**U.S. Department of Transportation  
Federal Aviation Administration**

**Airworthiness Directive  
Revision**

79-11-05 R1 MOONEY: Amendment 39-3480 as amended by Amendment 39-4050. Applies to Mooney M-18L S/N's 2 and up, M-18C S/N's 201 and up, M-18LA S/N's 100 through 200, M-18C55 S/N's 323 and up certificated in all categories.

(Docket No. 80-EA-47; Amendment 39-4050)

FIG. 17

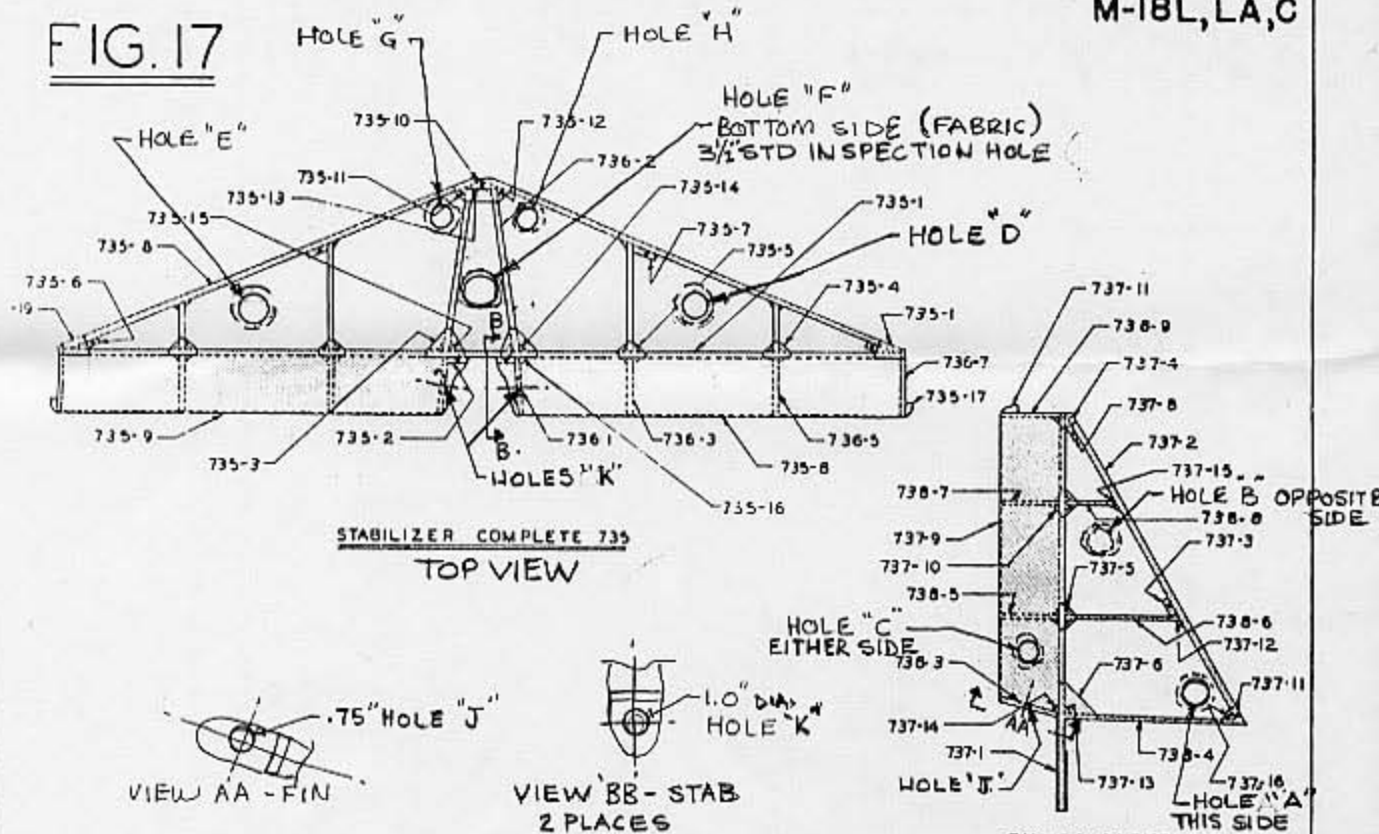
- (a) Cut 2.00 inch diameter holes in approximately the locations as shown on stab & fin drawing.
- (b) Cut a 2.62 inch diameter plastic ring with a 2.00 inch diameter hole from a .025 inch thickness material.

- (e) Follow the procedures (b) through (d) above for holes "A" through "H", except for hole "F". All holes in stabilizer are located on bottom side only.

- (f) The holes shown in view AA and BB should remain open. If hole "K" is to be used for inspection purposes, hole "C" is not required or vice versa; it's optional.

- (g) NOTE: Hole "F" is already an existing inspection hole in the bottom side of stabilizer.
- (h) Holes in fin are placed on either side or as noted on the drawing.

- C. In order to accomplish the stab & fin modifications of inspection holes to accommodate the AD note, the stab & fin assembly should be removed from the fuselage. In addition, it is best to disassemble the stab & fin for access to cut certain inspection holes for inspection of possible spar cracks and wood deterioration.

**FIG. 18**

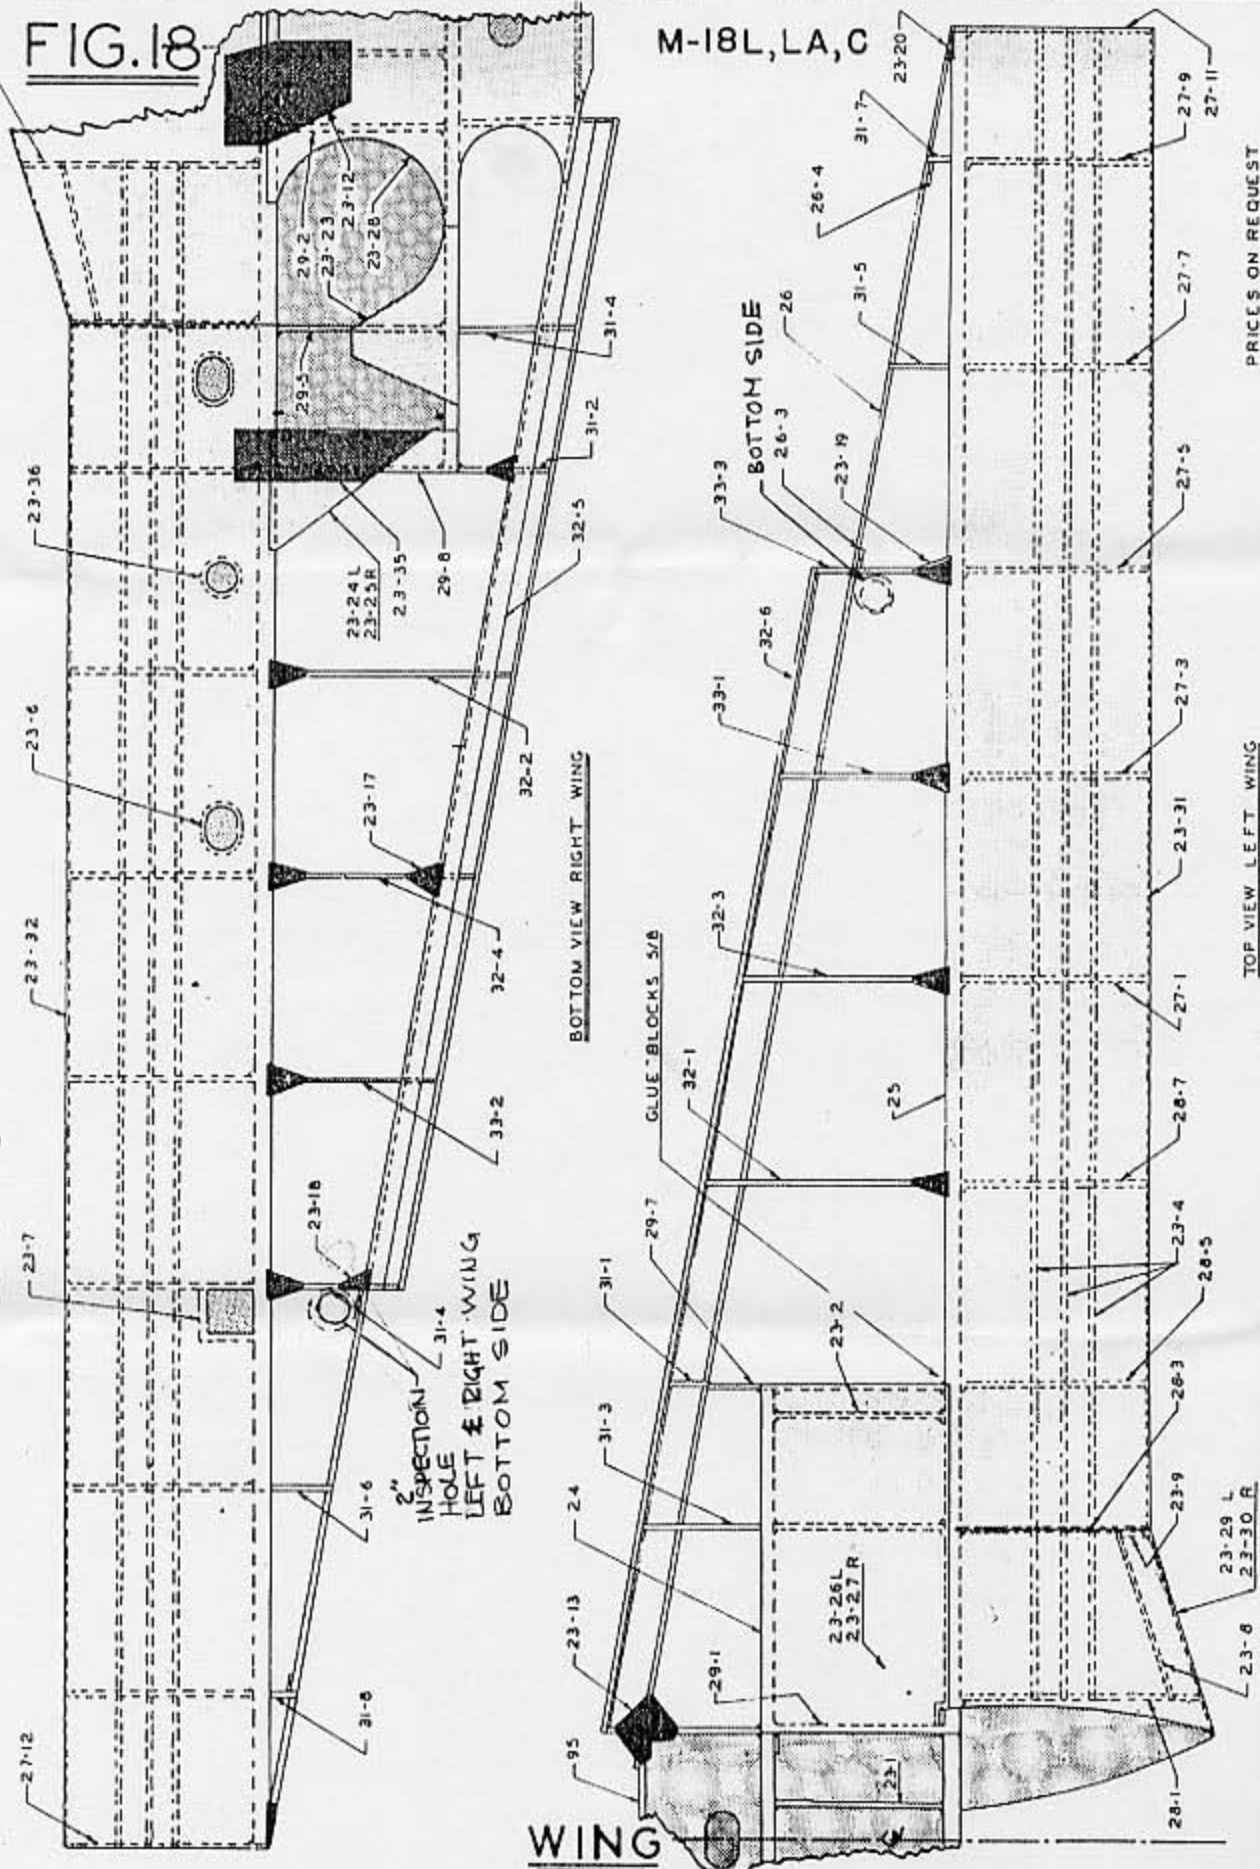
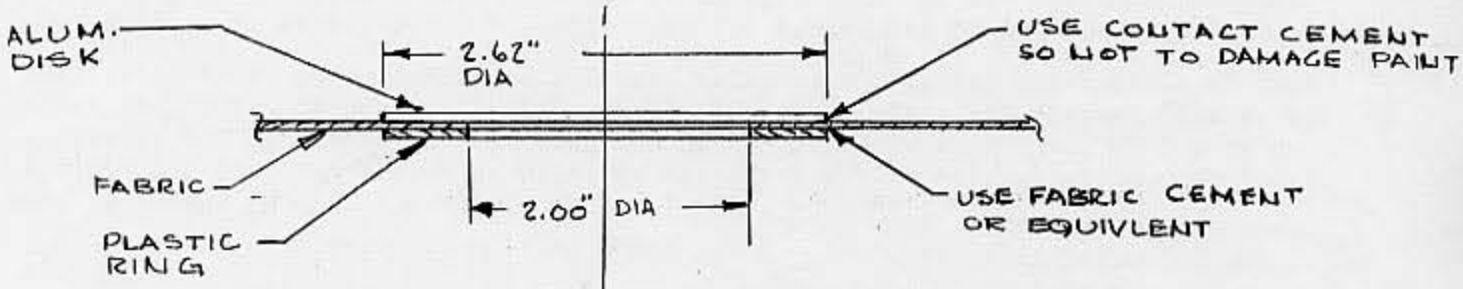
- (a) Cut 2.00 inch diameter holes in approximately the locations shown on the bottom side of the wing drawing.
- (b) Cut a 2.62 inch diameter plastic ring with a 2.00 inch diameter hole from a .025 inch thickness material.
- (c) Follow the same procedures (c) and (d) described for FIGURE17 stab & fin to complete the process.

TYPICAL INSTALLATION  
SECTIONAL VIEW  
OF INSPECTION HOLE

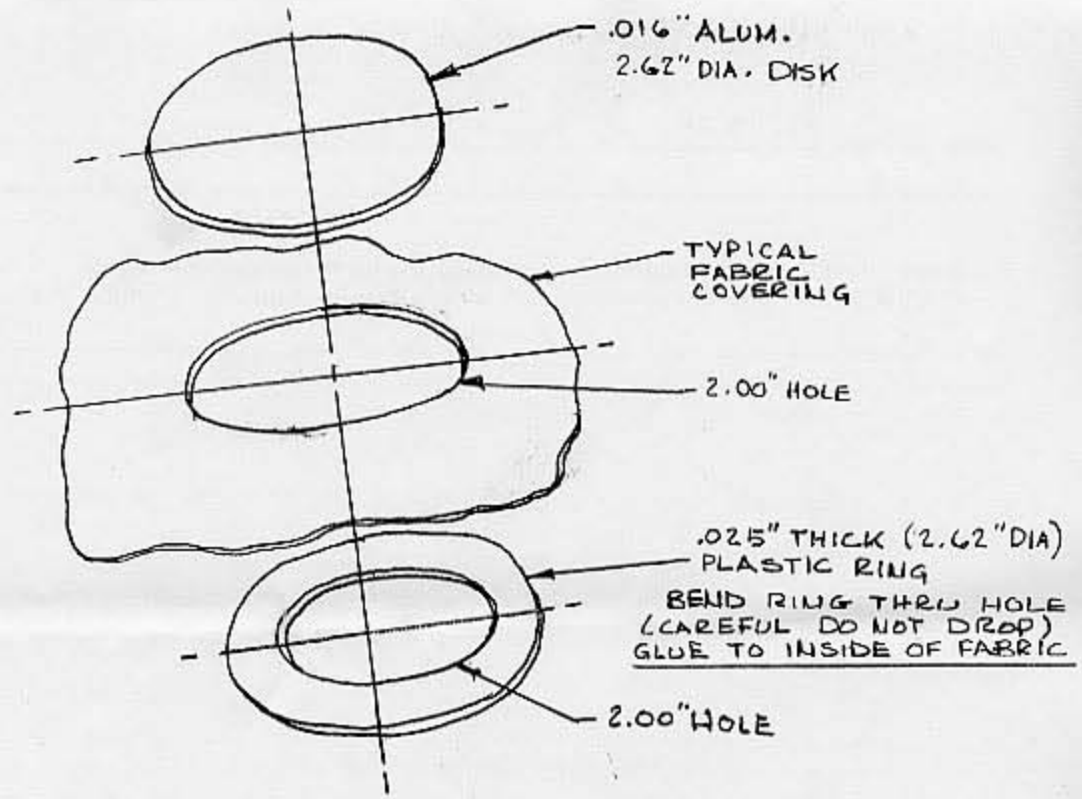
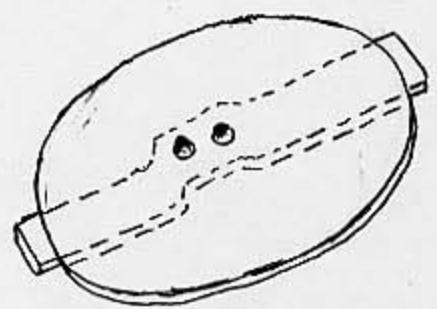
- (c) Insert plastic ring into 2.00 inch fabric hole and glue to inside. See "Typical Installation Of Inspection" drawing. Clip the plastic ring onto fabric with clothespins until dry. Take care not to drop ring inside in attempting to glue onto fabric.

- (d) Cut a 2.62 inch diameter aluminum disk, .016 inch thickness.
  - Paint disc with the same color as aircraft (one side only).
  - Apply contact cement to the edges of unpainted side of disc, ¼ inch wide of total circumference. This step is not required if using optional disc with clip.

NOTE: AS AN OPTION TO THE .016 PLAIN DISK SHOWN A CLIP CAN BE FABRICATED FROM THIN FLAT SPRING STEEL AND RIVETED TO DISK. SEE BELOW;
